HOWARD COUNTY HISTORIC PRESERVATION COMMISSION

August Minutes

Thursday, August 6, 2020; 7:00 p.m.

Figure 4 - Proposed location of garage

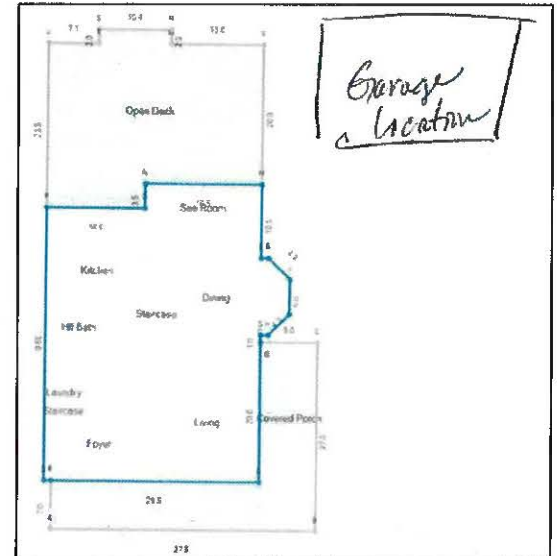
Ms. Tennor said the submitted plan shows the footprint of the residence and the proposed garage location but the existing driveway was not shown. Ms. Tennor also noted the existing shed where the proposed garage was sited was not indicated on the plan provided and asked if the existing shed will remain on the property. Mr. Wehland said the existing shed will remain but will be moved further back in the yard. Ms. Tennor asked if the reason for the existing shed being relocated was that the new shed would be too close to the garage. Mr. Wehland confirmed the statement to be true. Ms. Tennor asked if the existing shed will be located behind the proposed structure. Mr. Wehland confirmed that the existing shed will be located behind the proposed garage.

Mr. Reich said he took issue with the applications documentation as the location of the proposed garage was shown on an out of scale sketch. Mr. Reich told Mr. Wehland he would have to submit an accurate site plan for permitting and he was trying to understand the plan from the photo submitted. Ms. Burgess referenced the Agenda, figure 5, siting the existing red shed and where the proposed garage will be located. Mr. Reich said the existing shed is much smaller than the proposed garage and the site plan shows about 5 or 6 feet space between the house and the garage but the photo makes it look like there is 20-25 feet spacing. Mr. Wehland explained the layout of his property and where the garage will be in reference to the stairwell, gate and property line; the garage would be behind the gate, between the deck stairwell and the northern property line.

Mr. Shad said he agreed the garage will not be seen from College Avenue, however it would help to have a better site plan to see where the garage will sit in correlation with the deck and the existing shed. Mr. Shad asked if the application could be extended in order to get a more accurate site plan.

Motion: Ms. Zoren moved to approve the application as submitted contingent on the Applicant providing a more accurate site plan for Staff approval as well as a garage color sample for Staff approval. Mr. Reich seconded. The motion was unanimously approved.

Figure 8 - Proposed signs

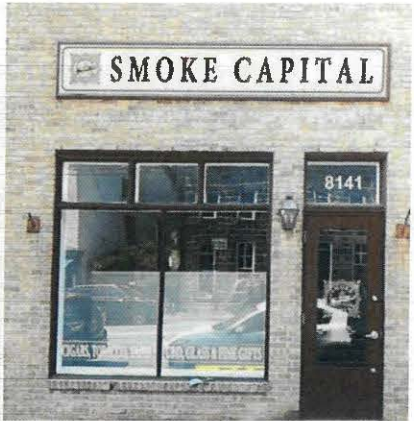
Mr. Reich said the raised panel looks like part of the design of the façade as it is above the display window, but below a three-panel window and the colors are in coordination with the composition of the brown and cream of the building. Mr. Reich said the Guidelines state the sign limit is 8 square feet and questioned if this façade was allowed a larger sign because of the existing 23 square foot placard panel on the storefront. Ms. Burgess said signs in this location historically have been the size of the raised

panel. Mr. Reich said if the Commission were to follow the Guidelines the sign approval should be for an 8 square foot sign within the area of the panel and does not necessarily fill up the entire square footage of the panel. Mr. Reich noted the approval of larger signs on wider buildings like 8307 Main and questioned how that applies to this smaller building. Mr. Reich said if the Applicant wanted to put up a sign in the panel area and filling the space to its entirety it would be within one of the Guidelines but not another. A 23 square foot sign would be visually distracting and the other two signs for approval would be over the top with what the Commission otherwise approves.

Mr. Reich said the photograph of the building is a light beige color and the Google Street View of the property has the brick looking darker with panel looking black. Mr. Reich said the drawing submitted is convincing. Mr. Alanesi said he wanted the sign to fit well with the building and be visible. A brown color is going to stick out and not be as clear which is why he chose the color of the sign background to match the brick instead. Mr. Alanesi said he thinks the color combination is the perfect match for the building.

Figure 16 - Proposed rear alterations

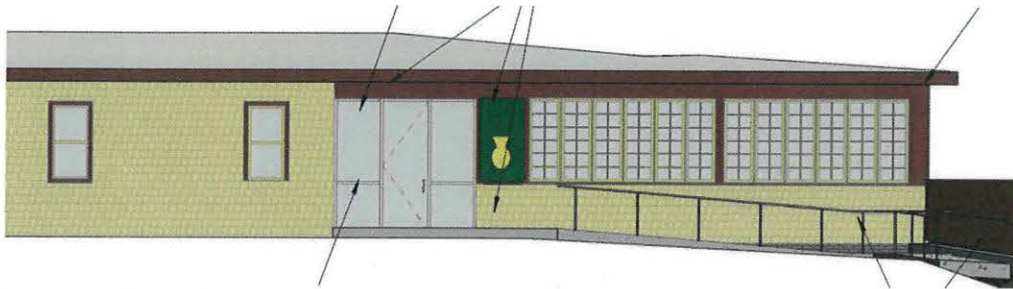
Ms. Tennor asked if the existing wall where the addition will be constructed was a lattice wall. Mr. Alexander said the wall is a parged block wall and has been altered a lot and the lattice has been added to allow something to grow. Ms. Tennor asked if the wall will be required to provide any structural support to the addition. Mr. Alexander said behind the lattice is a 12-inch concrete wall. Ms. Tennor said

Mr. Shad asked if Mr. Alexander would be doing anything with the existing parged retaining wall. Mr. Alexander said he was not going to alter the wall. Mr. Shad asked if the Applicant did not want to make the retaining wall blend into the wall. Mr. Alexander said the retaining wall was finished different with false ashlar block and then it goes to this lump concrete. Mr. Alexander said it would be better not to rip off vines and plantings. Mr. Shad said that 50% of the wall would not be seen either.

Figure 19 - Photo taken July 2020. Low brick retaining wall to be removed.

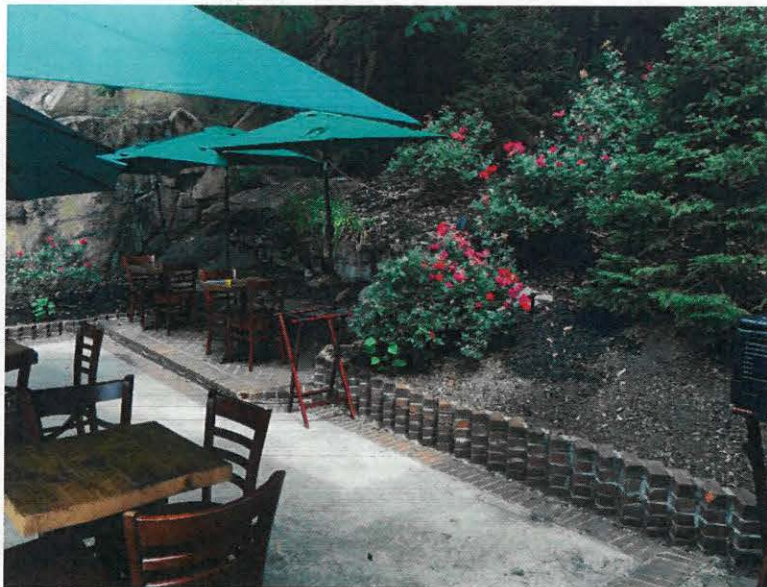
Ms. Burgess said she had conducted a site visit that day and Mr. Reuwer had been previously requesting a 5-foot wall, which is a structural wall and quite high. The property had a lot of mulch and dirt and it is unknown what the base soil type was. Ms. Burgess said after removing the mulch and dirt, it seemed that Mr. Reuwer could change the height of the request, but that would change the width, and having a tiered patio might be a better option. Ms. Burgess said Mr. Reuwer wanted to withdraw his application, but she had suggested Mr. Reuwer attend to get Advisory Comments on the tiered patio instead.

Ms. Tennor had some questions based on Mr. Reuwer's recent excavations. Ms. Tennor asked if the section drawing provided in the application is what the Commission should be referencing. Mr. Reuwer said they should not reference it, and that he would need to do some new measurements on the tiered patio. He said that it seems the first wall would not need to be as high because he does not want the patio sloping down and needs a level area to build on. Mr. Reuwer said that after removing the mulch and dirt, his team dug down until they got to rock they could not penetrate. The tiered patio would need to be about 4 feet to 4 and a half feet to prevent water running down and then the plan to make a second tier would require going back about 10 feet and then up another 3 feet.
